Date: September 26, 2016

From: Roger Phillips, PE

RE: Academy of Notre Dame de Namur – Preliminary Subdivision Plan
Goshen Holding Company, Inc. – Applicant

Preliminary Subdivision Plans – Academy of Notre Dame de Namur

SHEET 4C OF 23

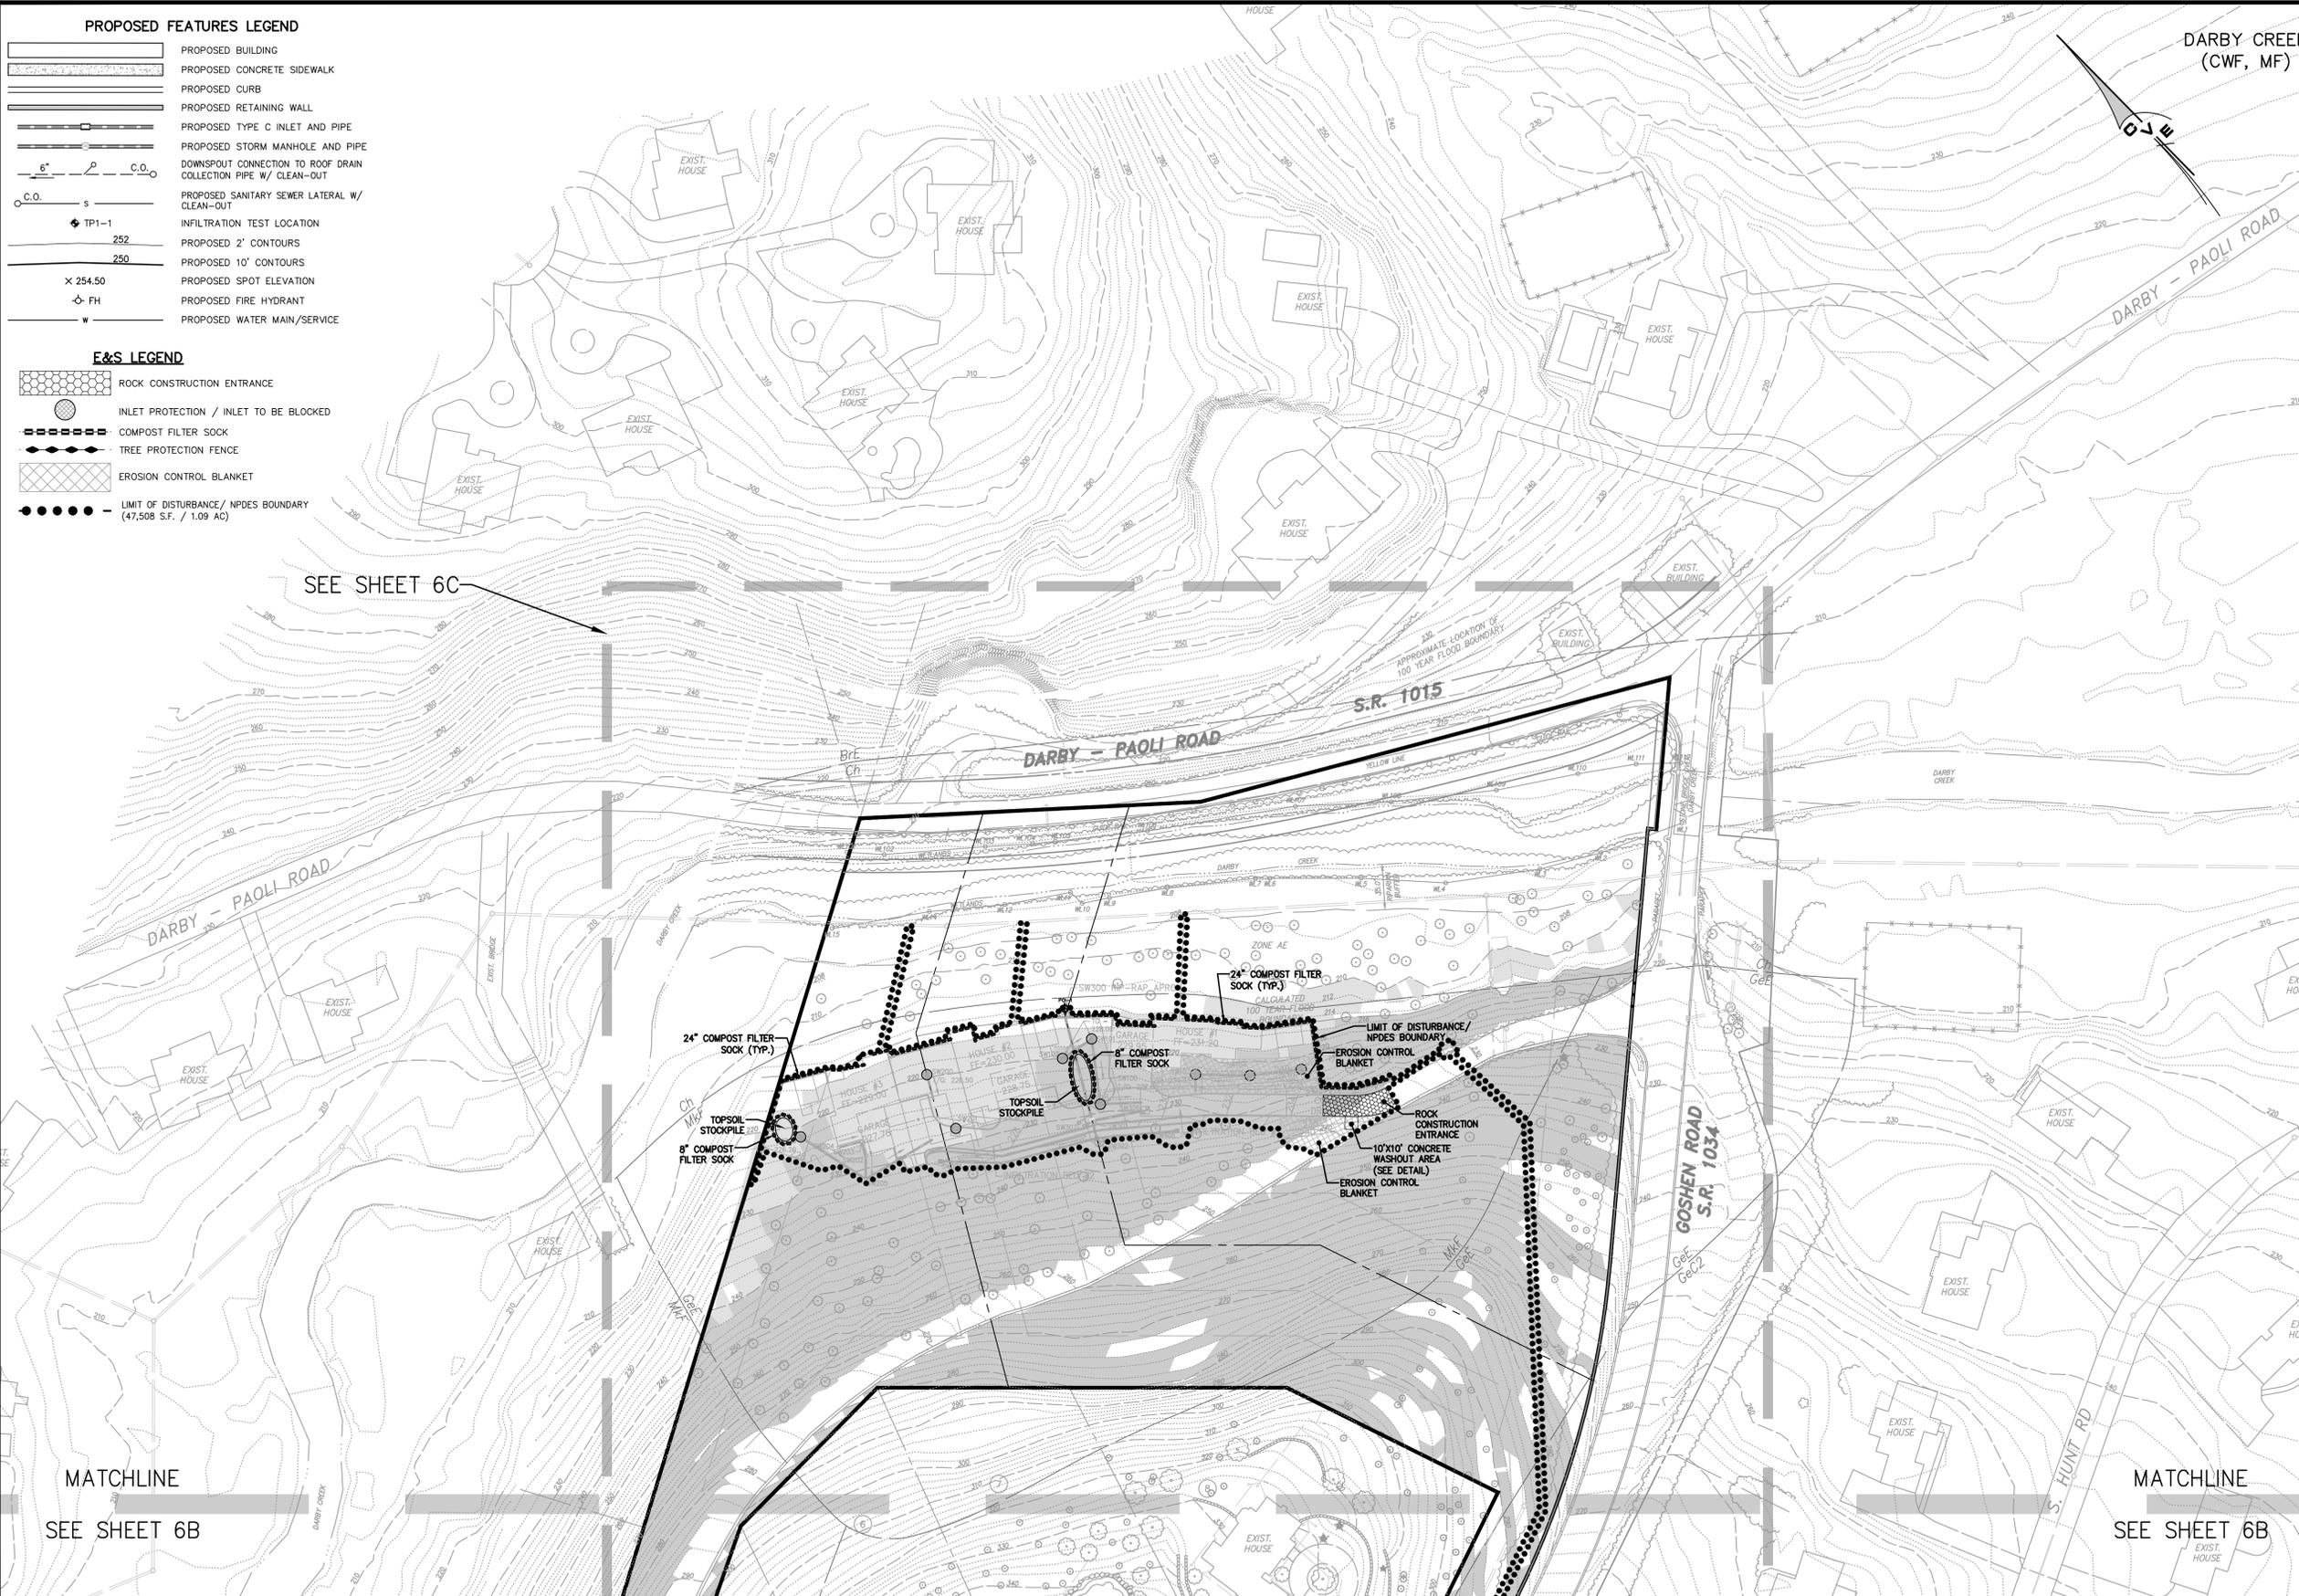
- Two (2) copies of the completed PADEP Act 537 Sewage Facilities Planning Module Application Mailer, including the Existing Features and Demolition Plan, Sheet 2C and the Grading and Utilities Plan, Sheet 4C

6. §255-20.B(1)(o)[8] – The project proposes a common driveway. No streets and no street lights are proposed for this project.
7. §255-20.B(1)(o)[9] – The existing fire hydrants on Montparnasse Place and on Goshen Road at Montparnasse Place intersection are noted on the Existing Condition Plans, sheet 2B. The proposed fire hydrant along the proposed common driveway is noted on sheet 4A.

13. §255-35.D – A 50' drainage easement along the existing watercourse has been added to the plans on sheets 3 and 4C.
14. §255-37.A - This subdivision proposes a common driveway to serve three lots. Since no streets are proposed, no sidewalks and/or paths are proposed.

8. §255-28 – The available and required sight distances for the PennDOT approved minimum use driveway entrance to Goshen Road have been added to sheets 4A and 4C.
